Interactive comment on “Hydrological control of large hurricane-induced lahars: evidences from rainfall, seismic and video monitoring” by Lucia Capra et al.

Response to RC2.

Fig. 1. Figure R1

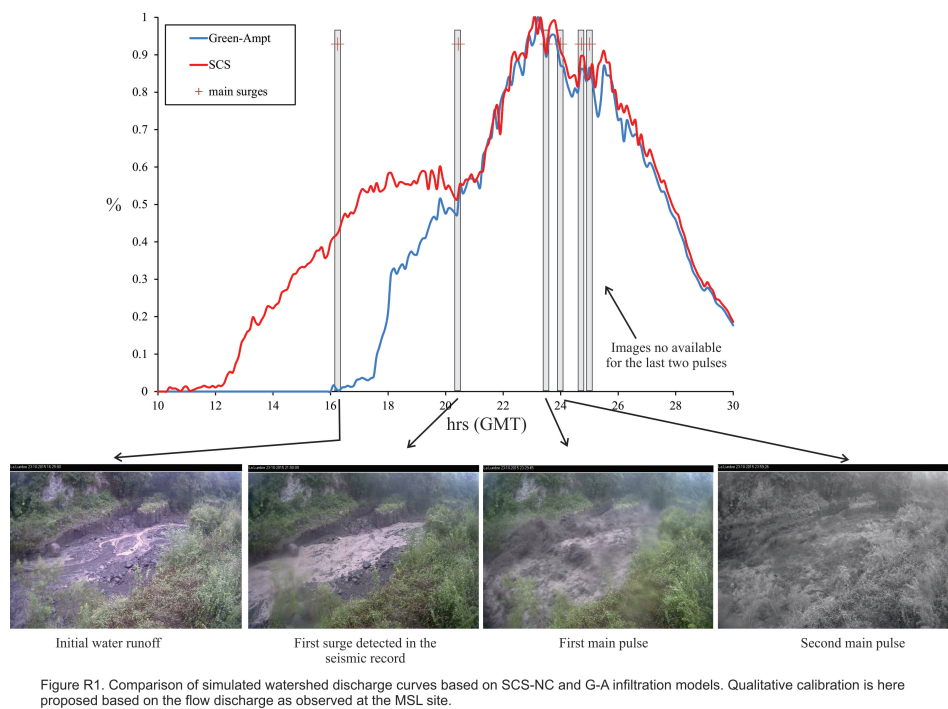
1. What are the assumptions of the SCS curve model and how may it affect results? The SCS approach is a simplified method for estimating rainfall runoff. Lower curve numbers result in less runoff for the same amount of rainfall. However, as stated on lines 229-231, this model simplifies the complex relationship between rainfall and overland flow into a single number. A weakness of this approach is that the curve number does not consider the effects of single storm properties (e.g. rainfall intensity) on infiltration.

R1: We agree with the reviewer that SCS-NC method does not consider the effect of the rainfall intensity on infiltration, a key point for the cases here analyzed. But it is worth mentioning that here the rainfall input for the FLO-2D simulation is given as a non-linear hydrograph curve where accumulated rainfall is discretized at each 10 minutes interval (as detected with the raingauge). Based also on the comment by L. Marchi (SC1), we tested the Green-Ampt (G-A) rainfall-infiltration method and we calibrated it with the images available for the Patricia event along the La Lumbre ravine, at least for the arrival time of the first slurry flow and for the main surges (this last correlation was already presented in fig.8). The parameters used for the Green-Ampt method were selected from FLO-2D reference tables according to the textural characteristics of the soil on the watershed (Table R1). The Ks (saturated hydraulic conductivity) of 20 mm/hr gives the best fit, and based on the equation proposed by Chong and Teng (1986) it corresponds to a CN of 75.5 in the range of the value used for the simulation performed with the SCS-NC method (see detailed explanation in the text below). It is worth to mention that the input parameters here used for the G-A model represent an average value for the entire watershed.

Figure R1 (see below) shows the comparison of the discharge curve obtained with the SCS and G-A methods and their comparison with selected images of the flow along the La Lumbre channel during the Patricia event. One first issue is the coincidence of the first water runoff along the channel observed in the image with the rise of the discharge in the curve modeled with G-A method, as the SCS-CN is not able to re-

produce it. In fact, we performed additional simulation to try to reproduce the initial slurry flow with the SCS method but it was impossible. This can be explained considering that the model automatically assumes an initial abstraction (rainfall intercepted by vegetation) of $0.2S$, where S is the potential retention included in the CN calculation ($CN=2540/(S+25.4)$) (Mockus, 1972), value that it is too high for the studied area. In contrast, the value of initial abstraction can be controlled performing the simulations with the G-A method. However, the main peak discharges corresponding with the main lahar pulses are equally reproduced with both models. Under this evidence, we are able to affirm that the G-A method is much more reliable to detect the first stream-flow, but the SCS method is also able to catch the main surges. One important point is that the simulations are here used to set up an early warning system to forecast the lag time of main lahar pulses at a specific site. The first water runoff along the channel was fundamental to calibrate the G-A simulation but it is not an essential data for the early warning system. In addition, input data for the G-A method are probably much more difficult to set, in contrast to the SCS method where only one parameter is needed. A new section has been added within the paragraph “2.4. Rainfall-runoff modeling” to show the comparison between the two infiltration methods based on which the SCS model was selected to be used in the early warning system. The SCS method has been largely used in rainfall-runoff estimations, and we consider that is a valuable method for the objective of the present work. This section was modified as follow:

Fig. R2. Normalized rainfall of the Jova and Patricia event as gathered from different stations, pointing to a quasi-stationary rainfall behavior.

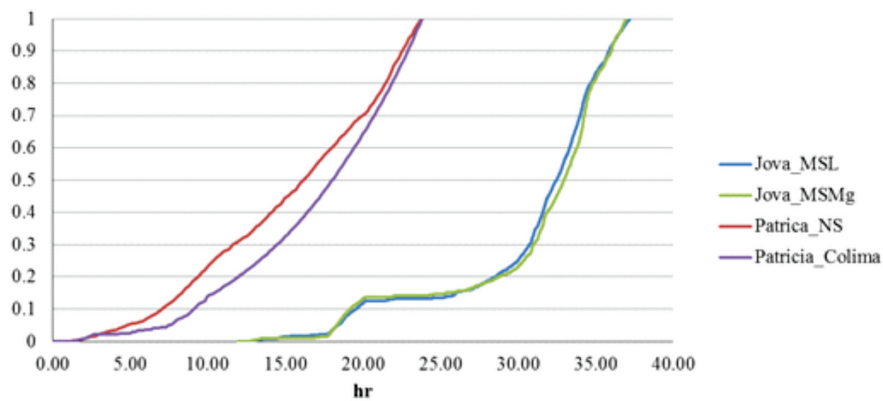
2. How was rainfall applied over the simulation domain? The authors state that the rainfall 10 minute intervals were applied to the simulation (lines 249-50). However, there is no indication if this varied spatially. If a spatially homogeneous rainfall input was used, the authors need to indicate this and, in discussion, consider the effect of this assumption on results and implication for the migratory, long duration rainfall scenarios.

R2: The rainfall was applied to the entire watershed, no spatial variation was assumed. As stated before, the total amount of accumulated rainfall is discretized in 10 minutes interval, introduced in the code as a no-linear hydrograph. During tropical rainfalls rains are nearly stationary on top of the volcano. This can be observed by comparing rainfall data from different stations (fig R2). This figure will be added as extra panel in figure 3.

Fig. 4. Figure 8 modified

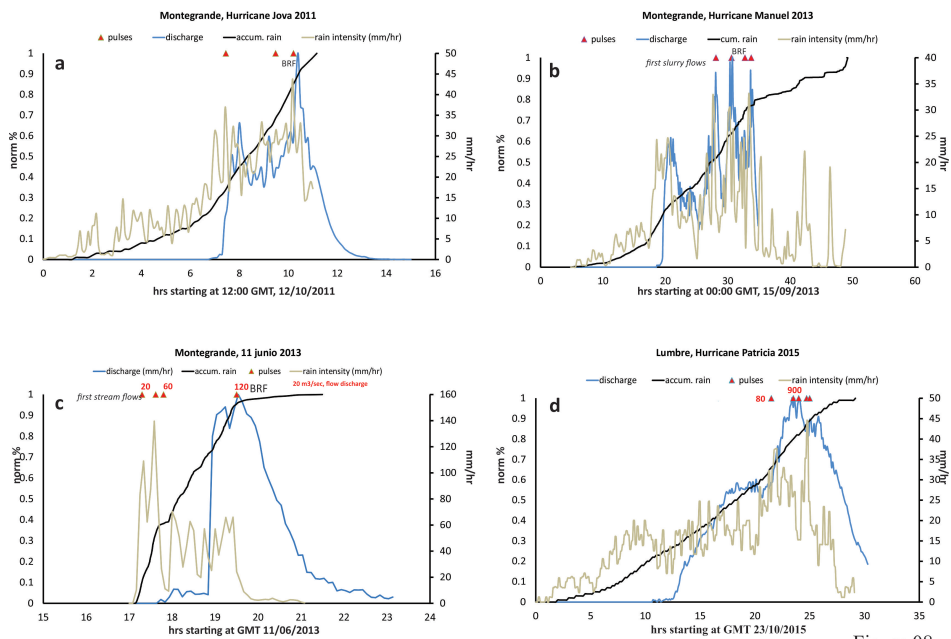
Fig. 8 needs to be improved, suggest the following:
• In the caption, rain intensity is a gray line, but in the figure it is gold/yellow.
• Fig. 8b - "Rain" and "Rain intensity" legend entries are switched
• Left axis (%norm) should only be between 0 and 1 (see above)
• Arrows in Fig. 8c do not seem to indicate anything - should "first stream flows" text be placed nearby?
• Color and line choice makes it hard to discriminate between rain intensity and discharge. Try adjust colors or line thicknesses.

Figure was improved as suggested (see next page)
